# Access Compliance Report

### (Curb Ramps)

Intersection ID: 10037212	Main Street: SANDY_ROCK_PL	Cross Street: N/A	Location: W
ADA ID: 5A60012F76B5	Ramp Type: Perp	Initial Pass/Fail: Pass	Overall Compliance: No
			Severity Score: 5
Codes/Mitigation Info/Possible Solution		Field Measurements/Component Compliance

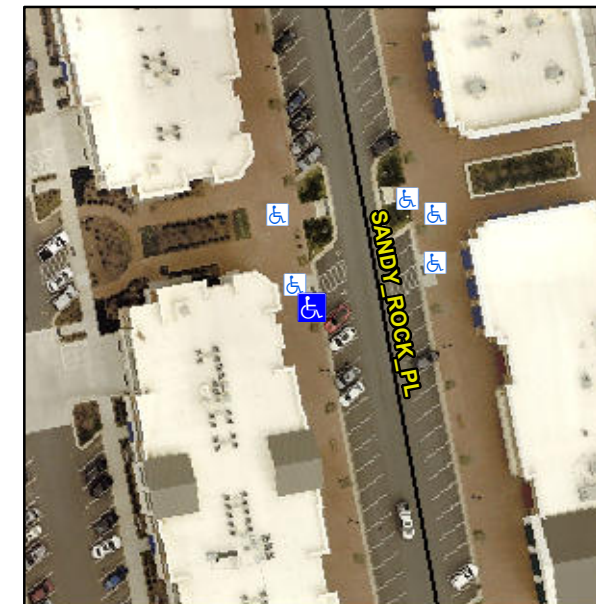
**Remove & Replace Entire Ramp.  
Remove & Replace Gutter.**

**Not Found, R304.5.4**
